Felicity Holmes
Department of Physical Geography
Stockholm University
106 91 Stockholm
felicity.holmes@natgeo.su.se

Response to reviewer one

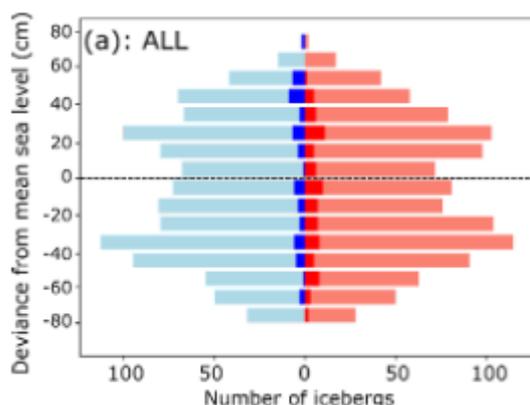
Fig. 4b/c: I find it very hard to distinguish between "All size" and "Large" in those figures. The presentation of the data should somehow be changed so that a straightforward differentiation is possible. I also think that this kind of plot is inadequate to visualize the results, as +80 and -80 cm are located in direct vicinity. A linear bar plot would be correct instead (it would also solve the problem that lines overlap frequently for small numbers of icebergs, which is in parts responsible for the problematic readability of the graphs).

The figure has been re-made so as to aid readability, with an example of the results from the ALL simulation shown below:

Fig. 7: I have some problems with this figure, too: While I like the idea of showing the profiles in perspective, I think this makes visual comparison of the undercut sizes almost impossible. In (a) sizes are given for profiles 2 and 3. It appears that the undercut in

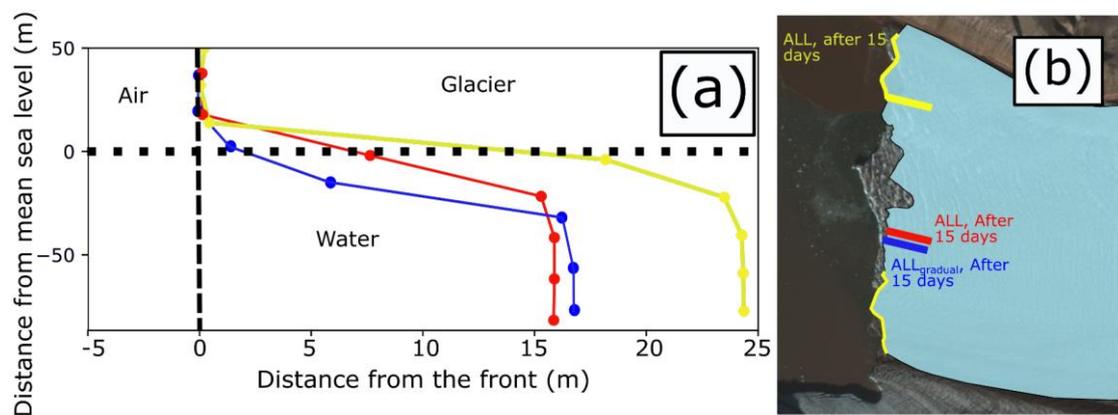
profile 2 is about four to five times as large as thin in profile 3, but this is by no means supported by the values given. Moreover, it is strange that profiles 1 and 4 are shown with their numbers, while undercut values are given for profiles 2 and 3. I suggest to change the presentation of the profiles in (a) to individual x (distance from calving front) vs. y (depth) line graphs. This would allow the reader to get the right idea of the sizes of the undercuts.

The figure has been edited so that it is now a line graph, which we believe makes it much easier to see the sizes of the undercuts, as well as to compare them to the observed undercuts. Undercuts are shown from a plume location (midway point of the simulation), and a non-plume location (midway point of the simulation). Additionally, an undercut from the new 'ALLgradual' sim is shown, where a less angular undercut is modelled. The updated figure is shown below:
